My objections:

- That the planning application has not considered NPF rules on **Ground conditions and pollution** in paragraph 178:
- The applicant has not supplied adequate information to demonstrate that the risks posed to groundwater can be satisfactorily managed.
- That the application does not address vertical movement of groundwater into the underlying principle aquifer, thereby influencing movement and cross contamination of the aquifers.

Fig 1

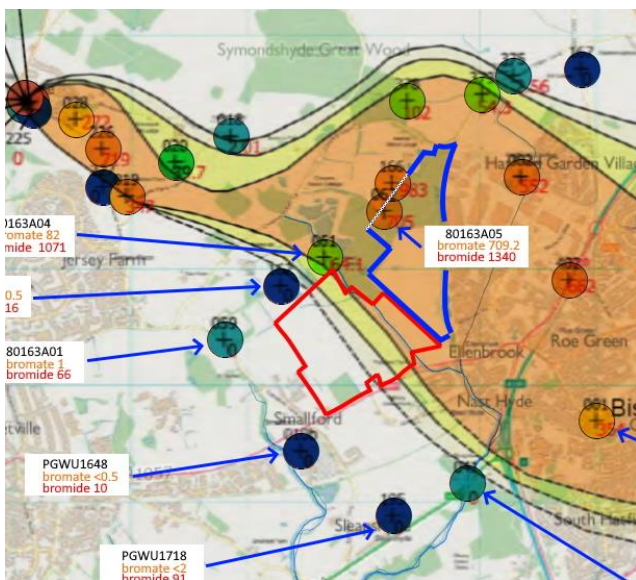
The latest plume drawing from Hatfield Quarry Application. Over 500µg/l (green) in the North where the planned housing would be:

This map was produced for the quarry application and shows the bromate contours under the housing site (dark green). The blue shows the southern part of the housing application.

EA plume drawing showing boreholes and housing applicant site. Borehole 80163A05 @ 709.2µg/l bromate is to the West of the housing site.

Fig 3

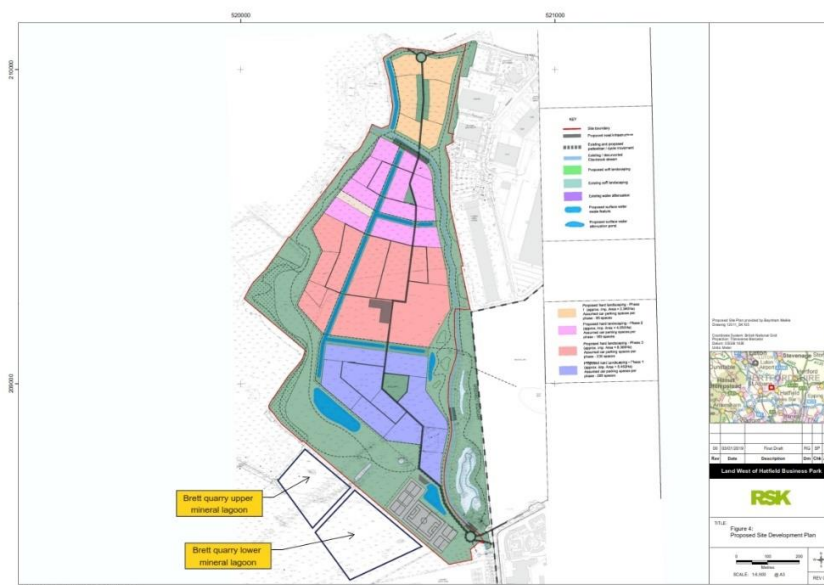
- that there is no mention of “adjacent/overlapping sites” such as the proposed Brett quarry to the East. Attenuation lakes practically touch Infiltration lagoons in a specific area - a catalyst for cross-contamination ...see fig 3.

- The cumulative effect of attenuation lakes in the South and Brett quarry infiltration lagoons in the same area was not taken into consideration Fig 3.

Fig 3 shows proposed Brett quarry lagoons in the South. The expected infiltration rate of UML is 1,100 to 2,300 cubic metres/day directly into the same ground that the attenuations ponds (blue) would add another 1000 to 2500 cubic metres/day.

These totals double the groundwater amount, which is now focused on a specific area potentially leading to flooding downstream of the combined sites.

Fig 4

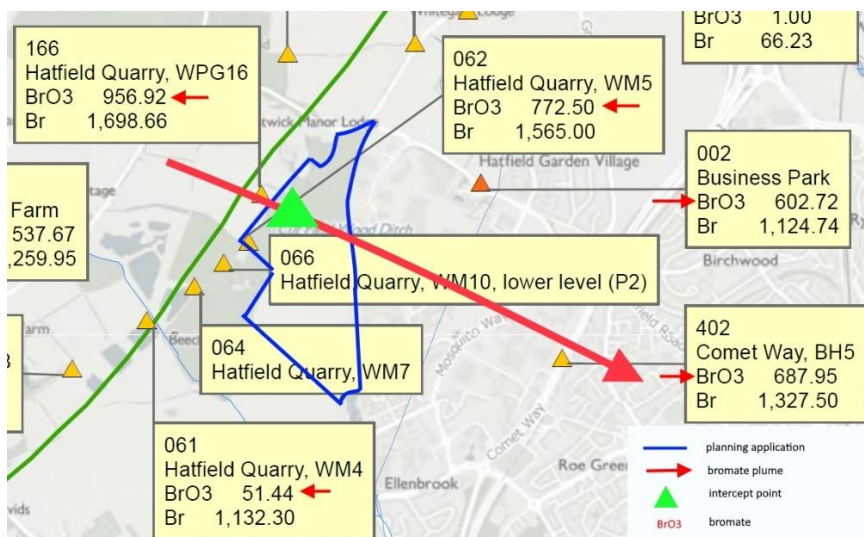
- The objection is that the EA remedial plan using an array of boreholes, perpendicular to the plume and at its highest bromate levels, would require an area to operate that is clear of obstacles and housing.

The intercept point is shown in green. The plume has a S.E direction.
